**PRIMARY ROAD SYSTEM
FAYETTE COUNTY
BRIDGE REPLACEMENT**

IA 93 - Stream 0.7 mi W of Co Rd V68

FIELD EXAM MARK-UP

Field Exam held virtually on 6/14/21

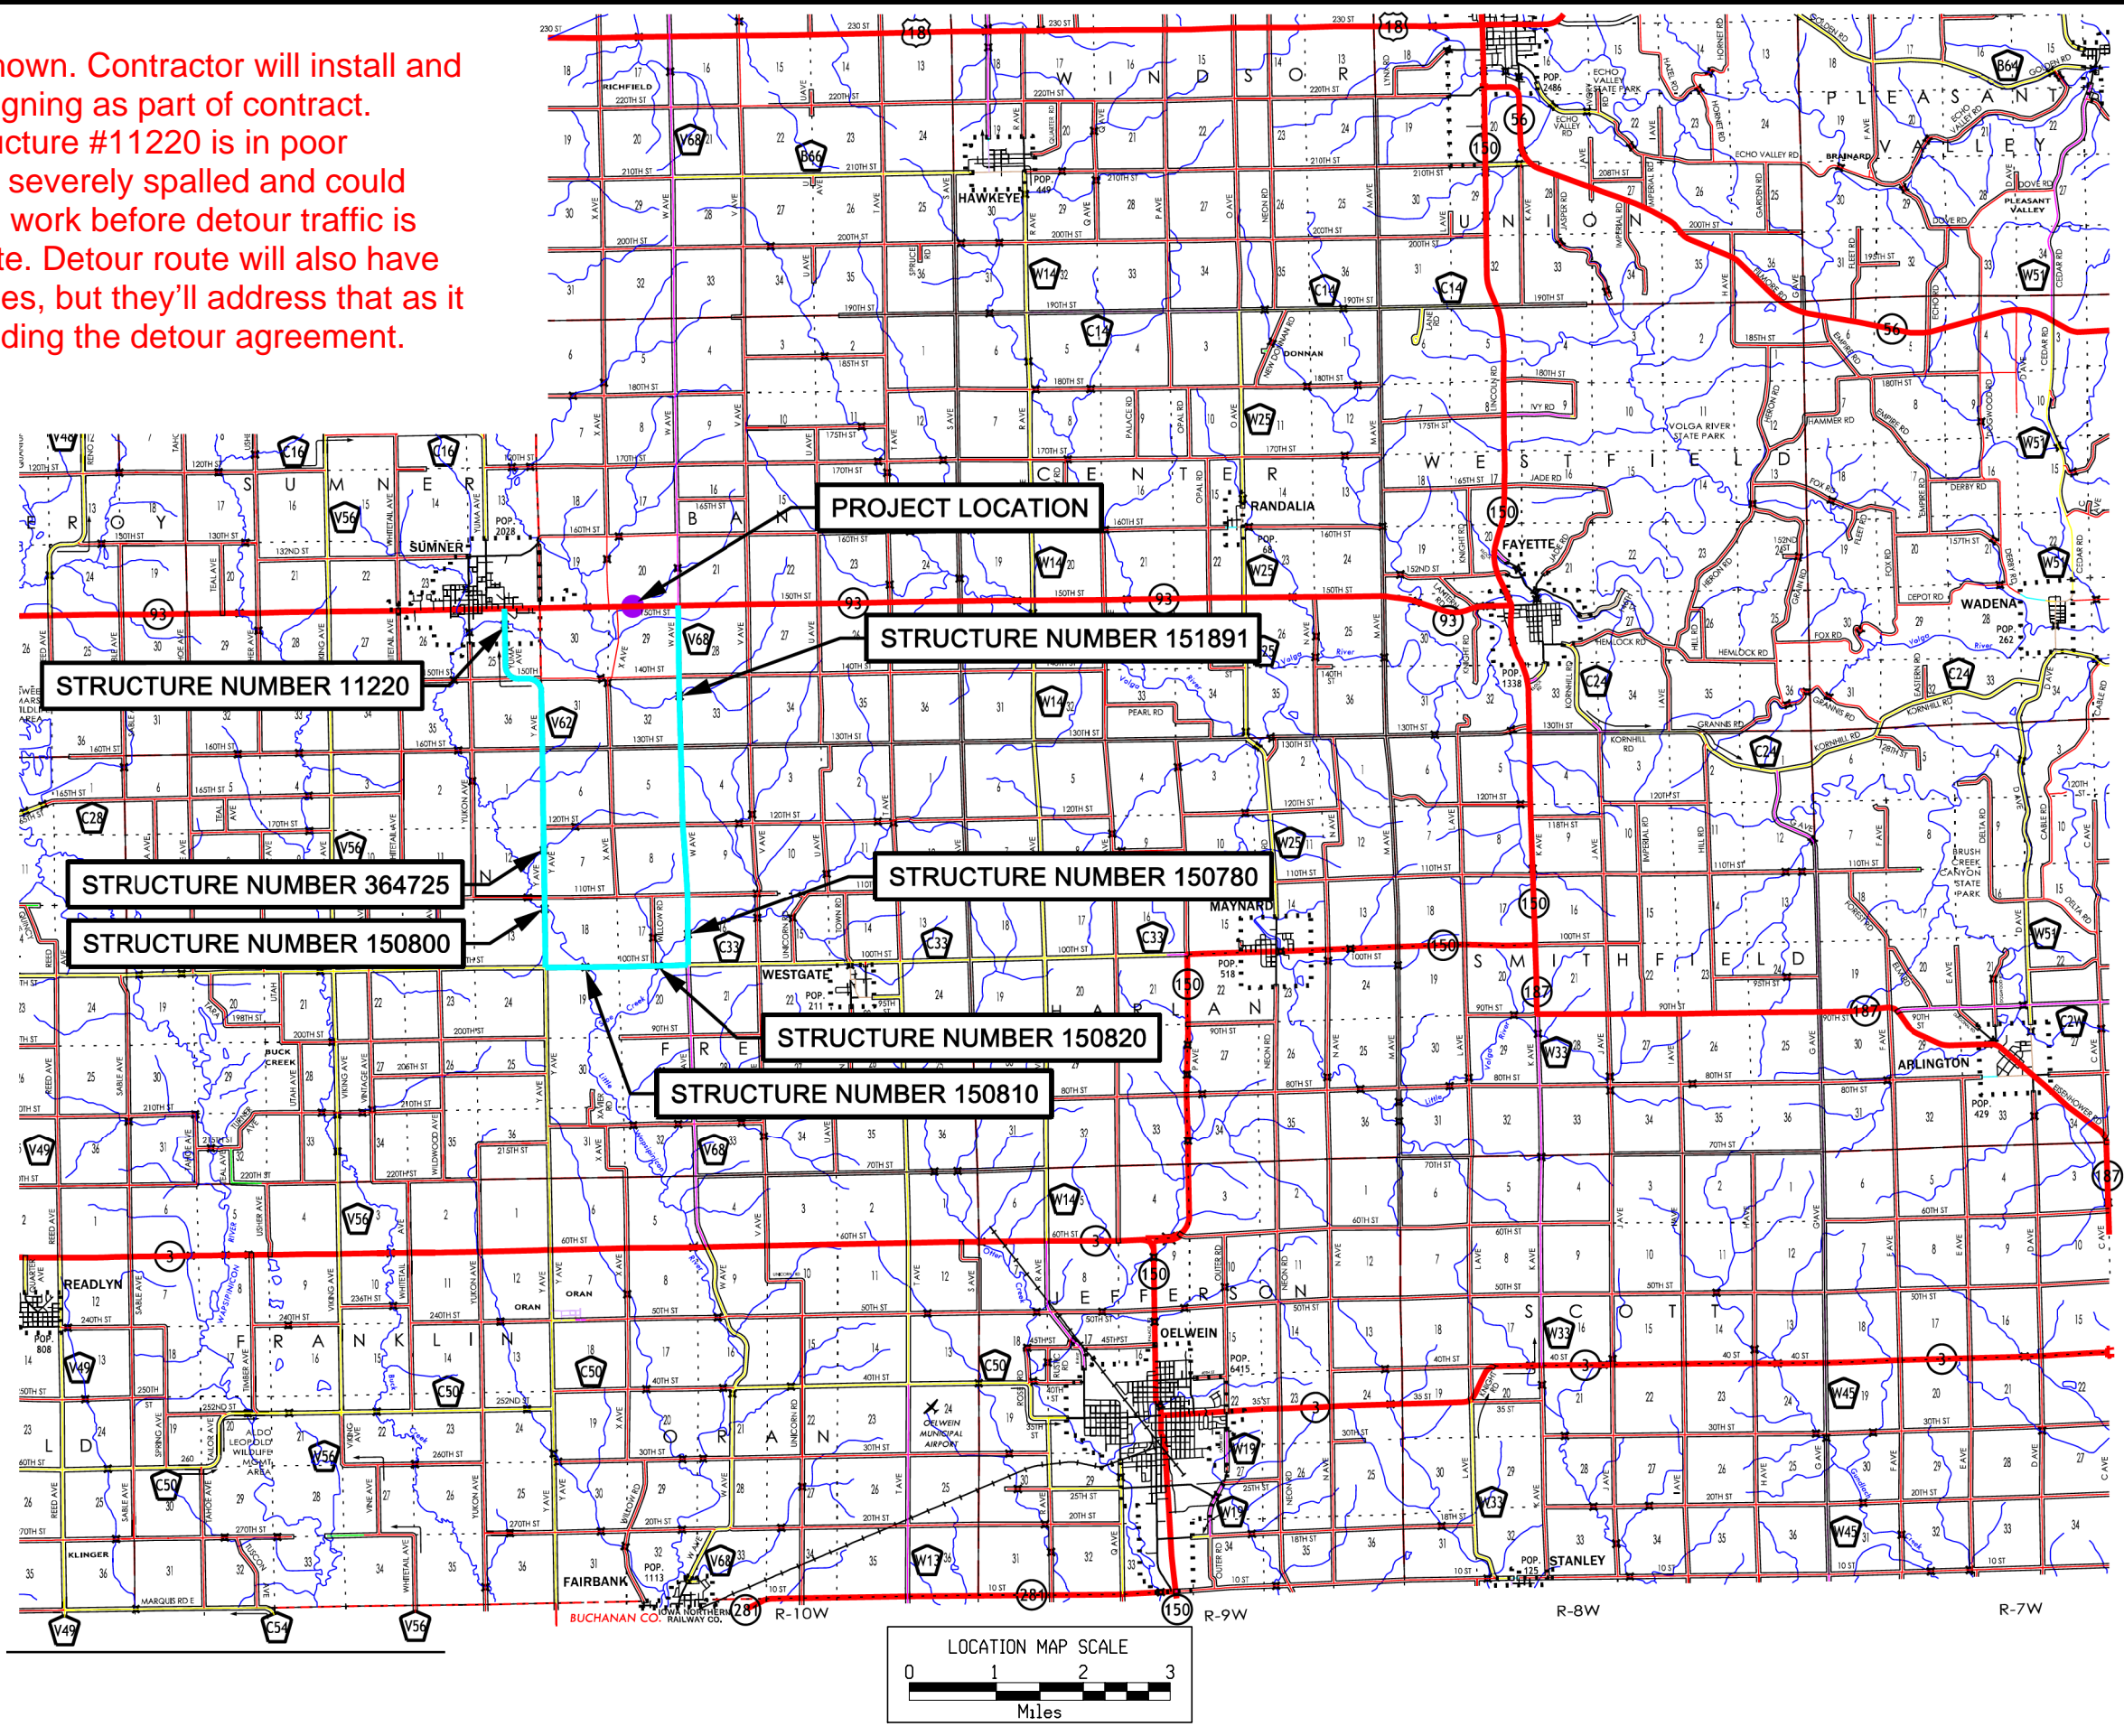
Detour okay as shown. Contractor will install and maintain detour signing as part of contract. District stated structure #11220 is in poor condition. Deck is severely spalled and could use some surface work before detour traffic is placed on the route. Detour route will also have a few sign upgrades, but they'll address that as it gets closer to needing the detour agreement.

G_2_Grade_BR
04-21-20

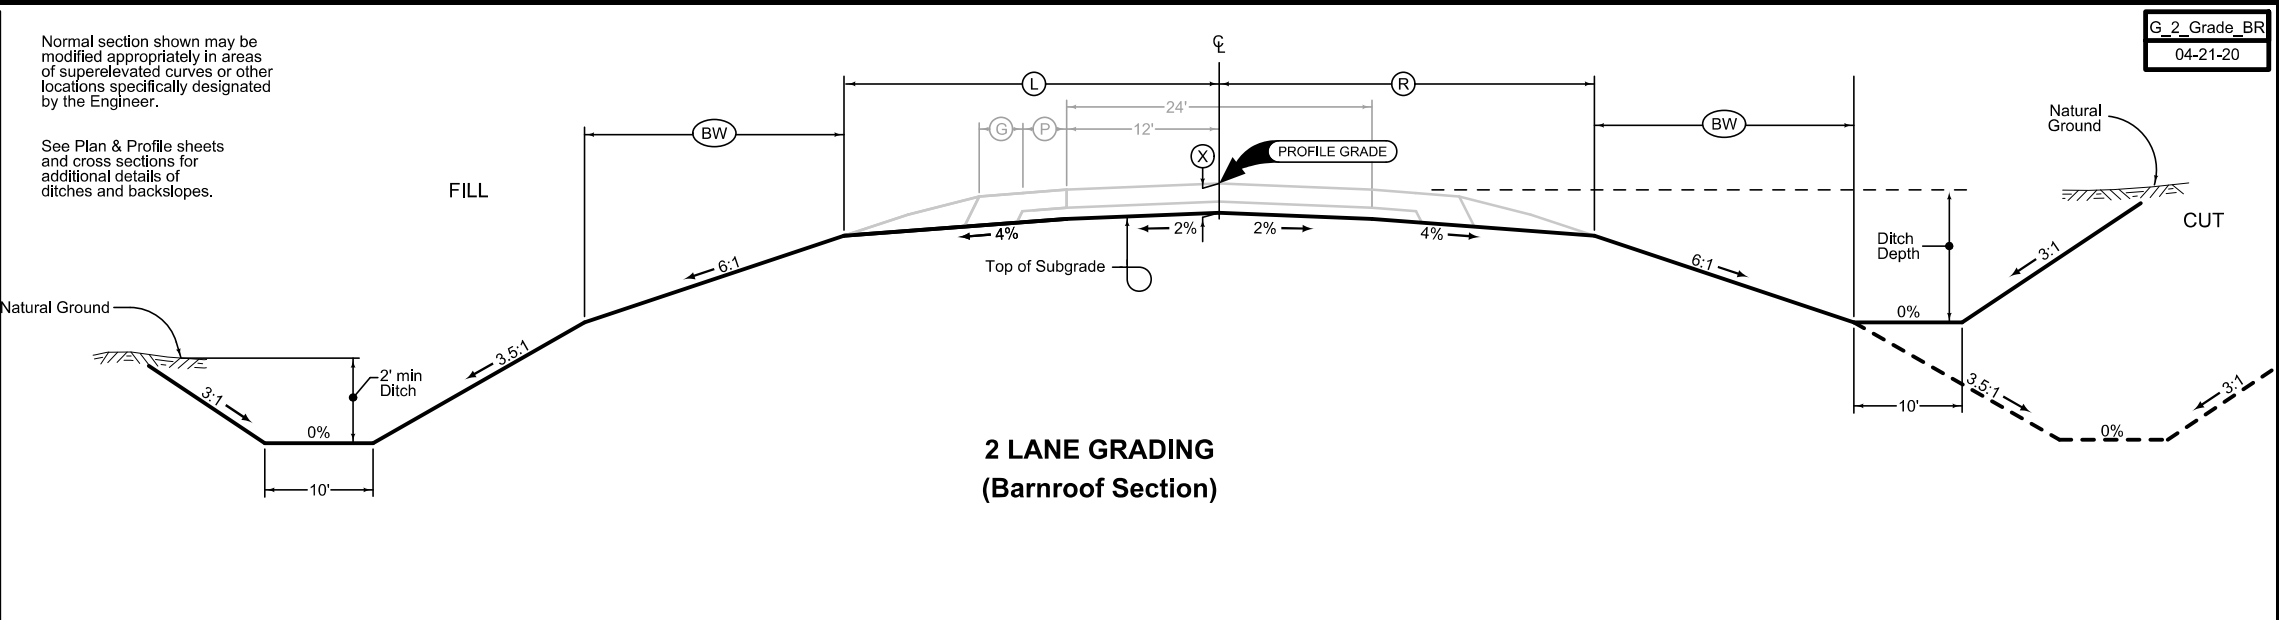
District's comment: Rather than fully updating the short section of foreslopes to accommodate the RCB, I'd recommend more closely mimicking the existing conditions. Perhaps the foreslopes can be 4:1 rather than the barn roof currently shown. (This will be reviewed and incorporated into the D3 submittal.)

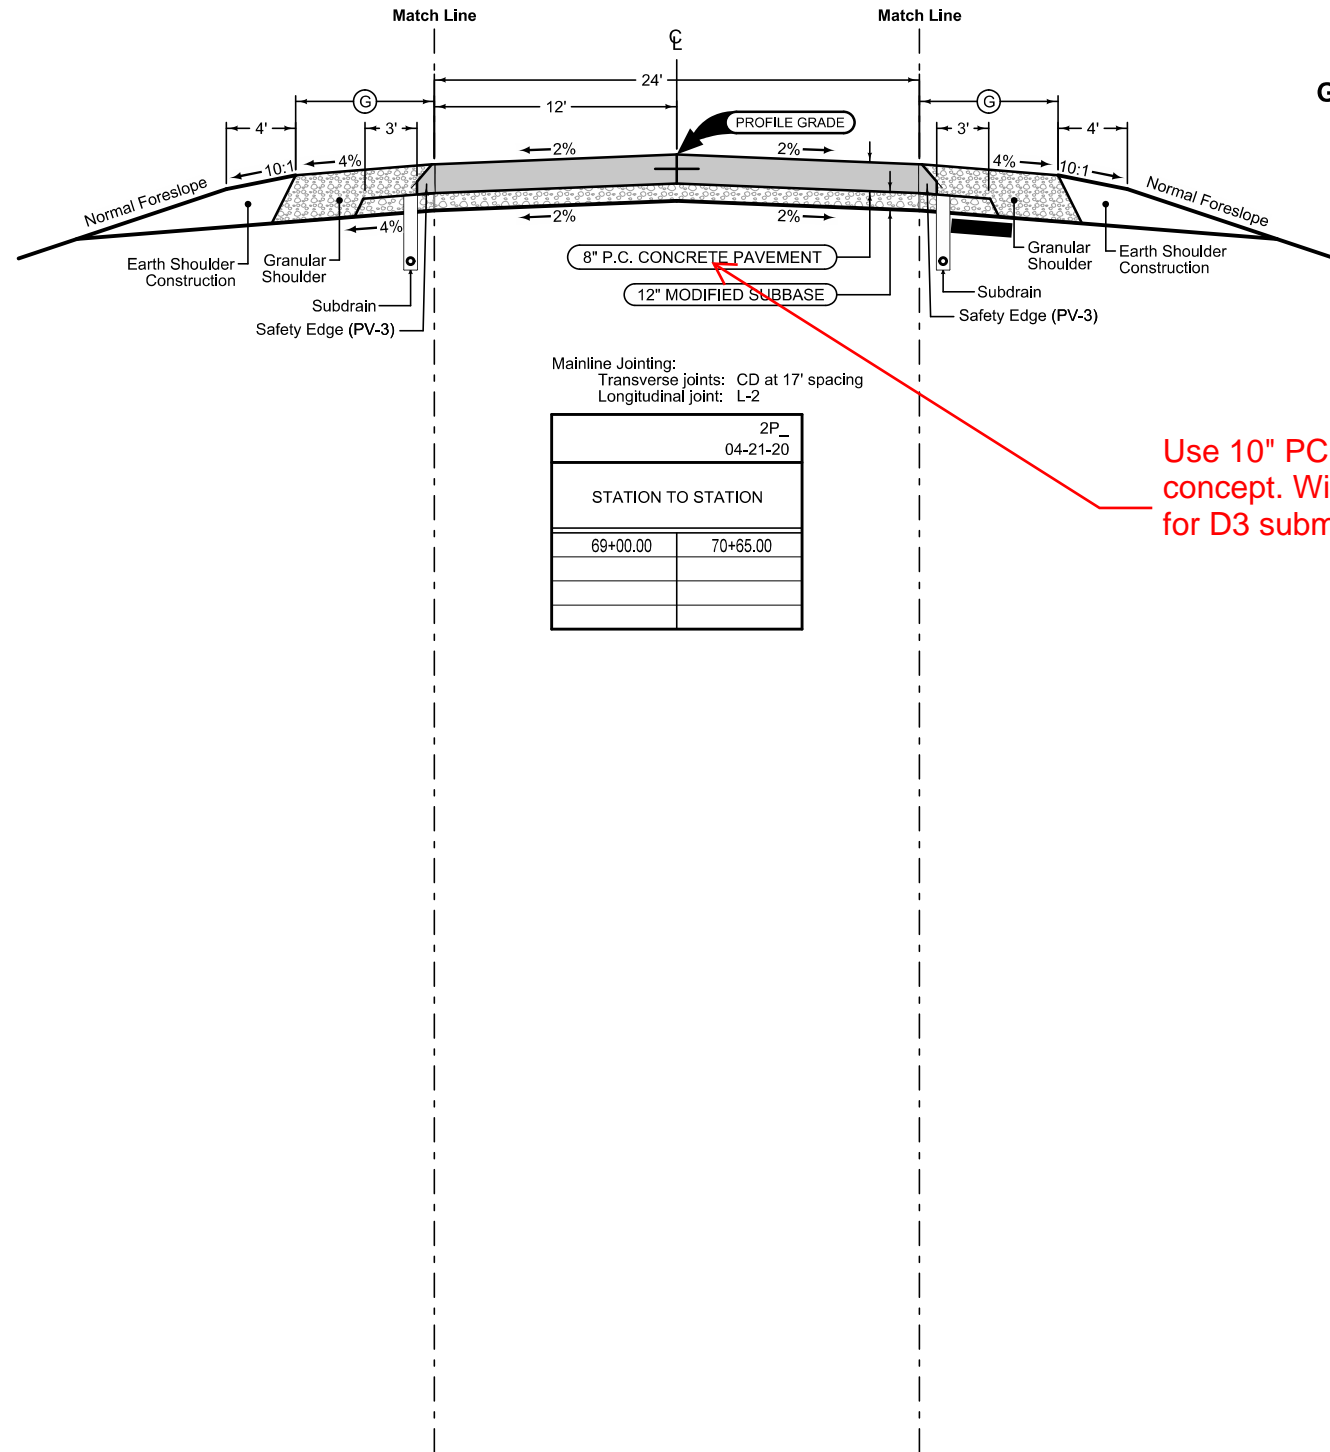
Use 10" PCC as per concept. Will update for D3 submittal.

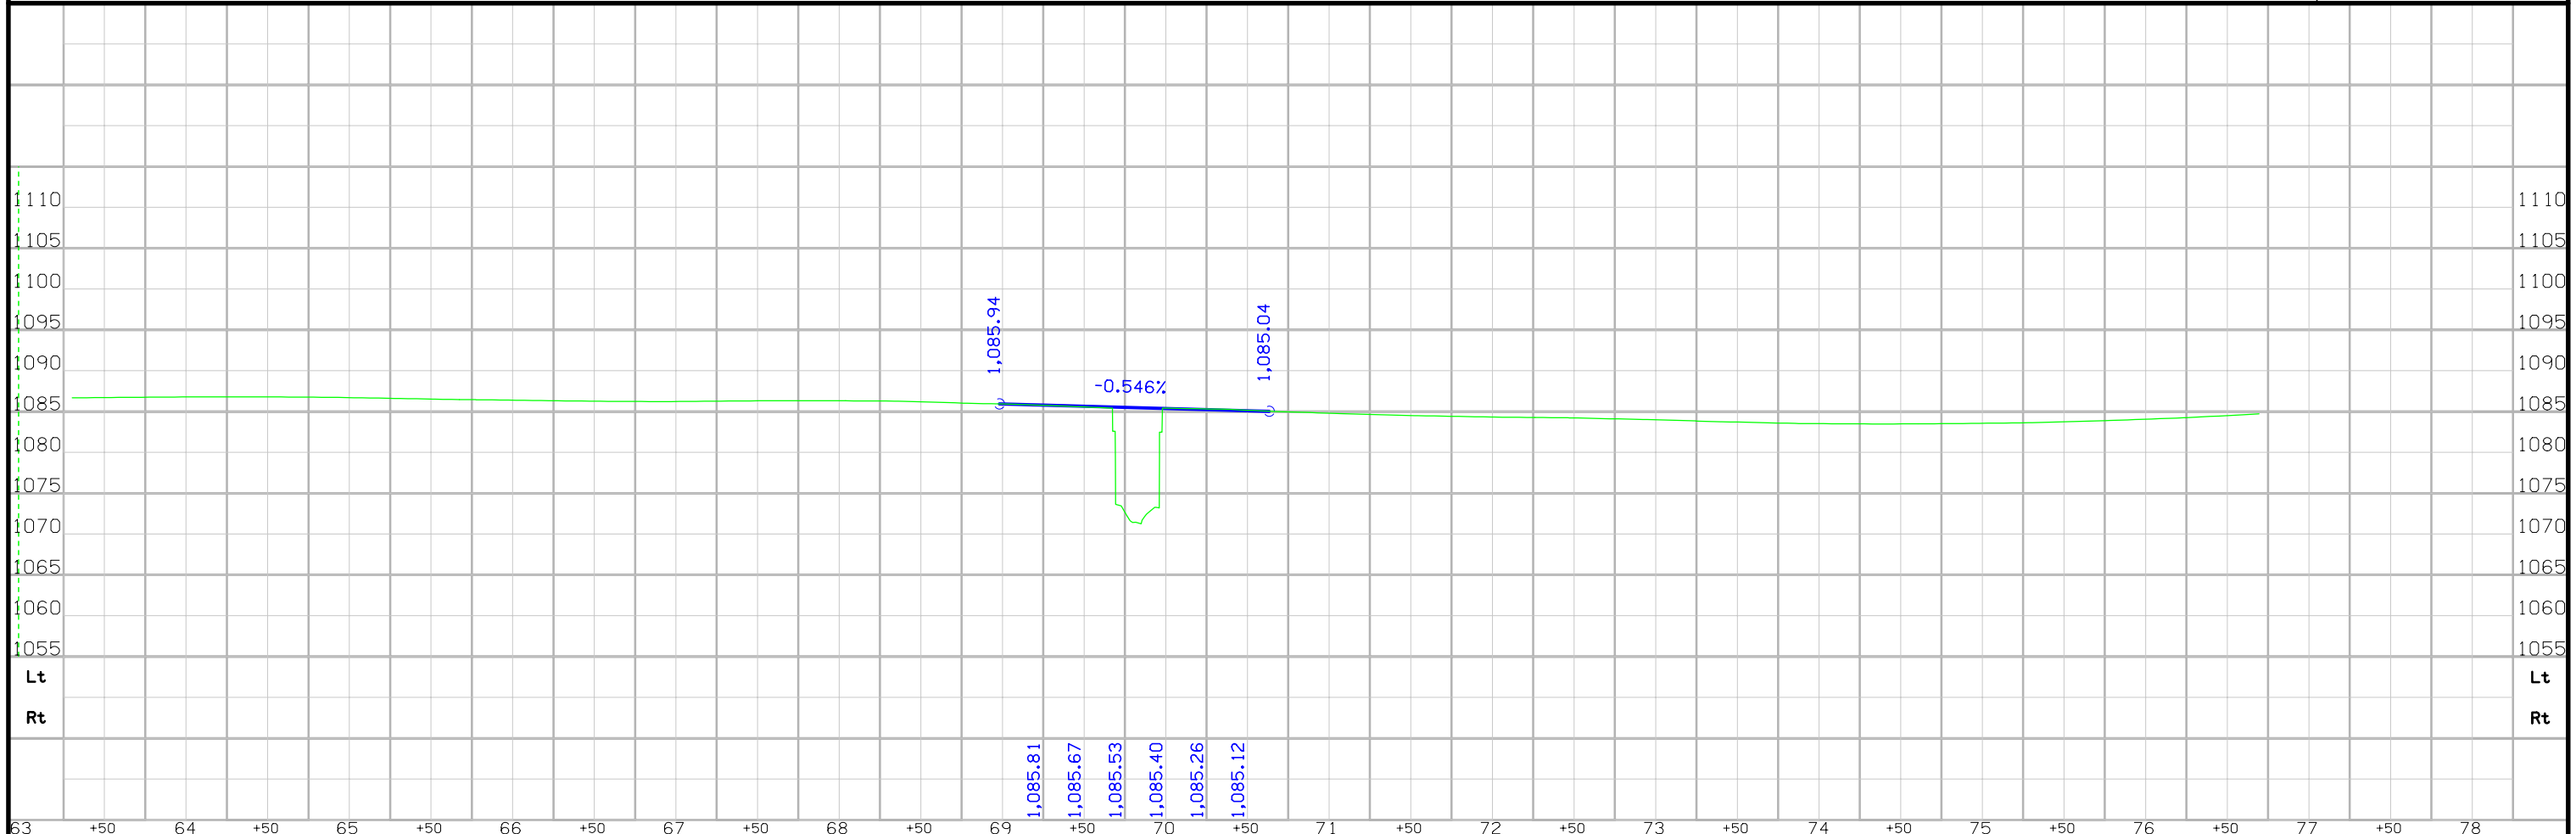
As per District review: west end of entrance pipe needs one section reset, east end needs one section replaced and aprons need added to both sides.
